SERVICE BULLETIN

NO. 96

Sec. VIII, Div. A
Service Bulletin #96
Issued December, 1962

REPLACEMENT OF FUEL TANK ON 426 SERIES ENGINES

426 SERIES ENGINE

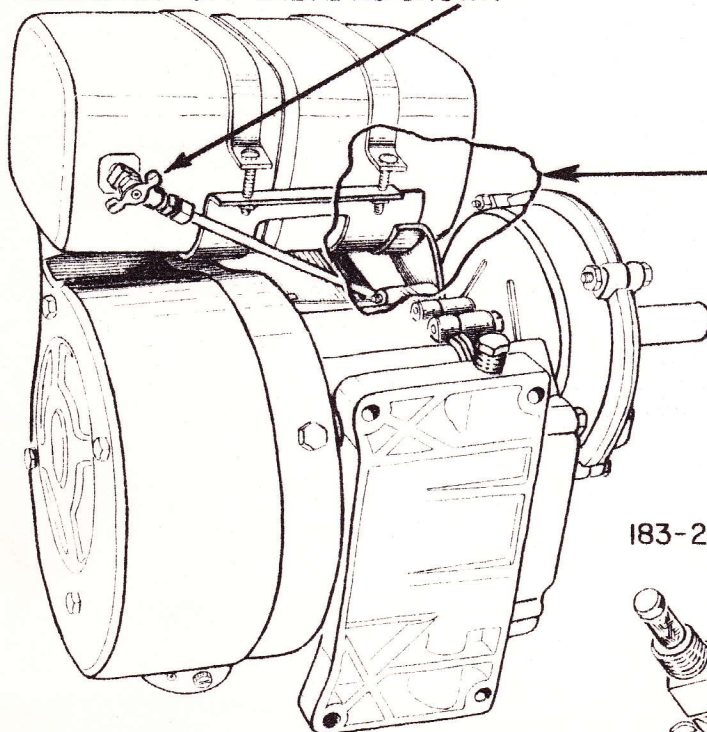
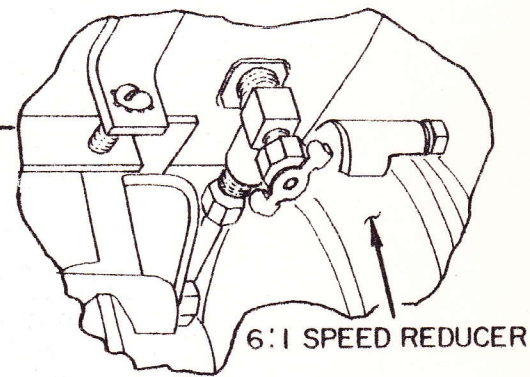
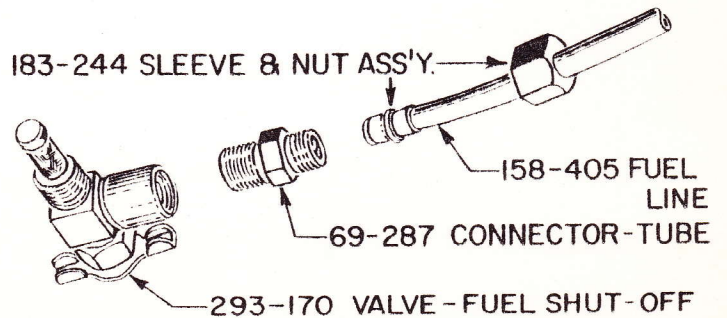
This applies only to 426 series engines with 6 to 1 Gear Reduction Unit. The Position of the Replacement 277-449-5 (See Illustration) Tank varies from the position as originally used in factory assembly as Noted Below.

Originally the fuel shut off valve 293-170 and the fuel tank 277-436-5 was too near the gear reduction unit causing damage to fuel tank and/or fuel shut off valve. The tank has been redesigned, this will require the use of a longer fuel line Part No. 158-405. The fuel shut off valve has been relocated on the replacement tank. Originally it was located opposite the filler neck. It is now directly below the filler neck.

277-449-5 TANK ASS'Y-FUEL RELOCATES FUEL SHUT-OFF VALVE AS SHOWN

POSITION OF FUEL SHUT-OFF VALVE WHEN 277-436-5 TANK ASS'Y. WAS INSTALLED AT THE FACTORY.

To prevent damage to the fuel tank and shut off valve, use a 277-449 tank, 158-405 fuel line, and two 183-244 sleeve and nut assembly.
